UNITED STATES OF AMERICA
NUCLEAR REGULATORY COMMISSION²⁶

AFFIDAVIT OF ROBERT H. TURNER

Subject: Evaporation Pond
Palo Verde Nuclear Generating Station
File: 80-003-028.6/CM-020

SUBJECT: Palo Verde Evaporation Pond (7-54)
General description and hazard
classification.

The hypalon liner being terminated on the upstream side of the crest. Trench dimensions: 12" w x 12" d.

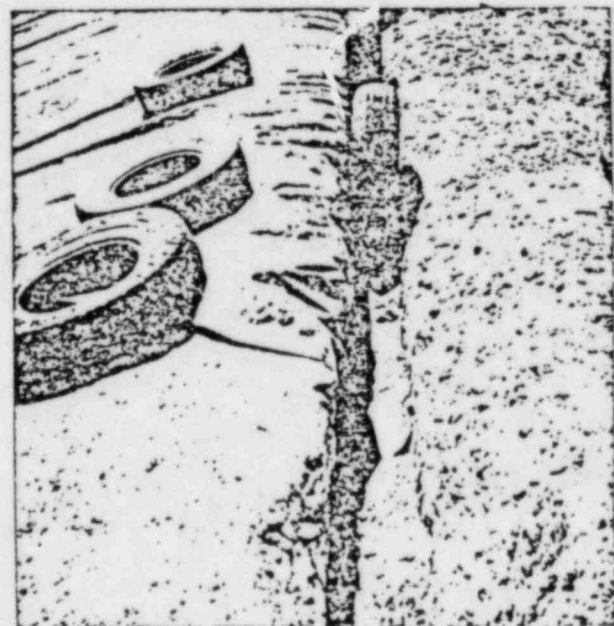
1. The liner appears to be sound and sturdy and quite satisfactory.
2. The jointing of the different sections and the 3 ft. overlap is in accordance with the specifications.
3. The rupture in the lining material noticed at few locations is patched up with sufficient overlap.
4. Termination of the liner at the downstream toe is not completed.
5. There are some questions about the contractor's methods of terminating the upper end of the liner on the upstream end of the crest. The construction drawings (which were reviewed and approved with the understanding that the liner will be placed according to the manufacturer's specifications) call for 12" deep trench, whereas the manufacturer's specifications require a minimum of 18" deep trench.

In my opinion, the trench depth giving a soil cover of 12" is not sufficient to prevent movement or the downward drag of the liner due to settlement, wave action and the hydrostatic forces.

I discussed this with Dick McGregor at the site and Joe Kanovich (both of APS) after my return to the office and asked them to look into the matter before it is too late. To insure sufficient anchorage we would require that the manufacturer's specifications of the 18" minimum trench depth be followed. Further, the contractor is presently backfilling the trench without compaction. I suggested, 6" layers of uncompacted thickness should be hand tamped with proper care taken to protect the liner from damage. Joe Kanovich told me he will discuss these points with Goodrich and Bechtel staff and call me back.

Discussed with Dick McGregor and Dick Anderson the discrepancy between the manufacturer's specifications and the construction drawings on the required depth of trench to terminate upper end of the hypalon liner near the upstream crest. It was finally agreed that Bechtel will issue the work stoppage notice (NCR) to the contractor and refer the problem to their design office in Downey, California to verify if the 12 inch depth of trench (as is being built according to the drawings) or the manufacturer's specifications requiring 18" depth should be followed. The hypalon lining work was, as such, stopped from the afternoon of 9-23-81.
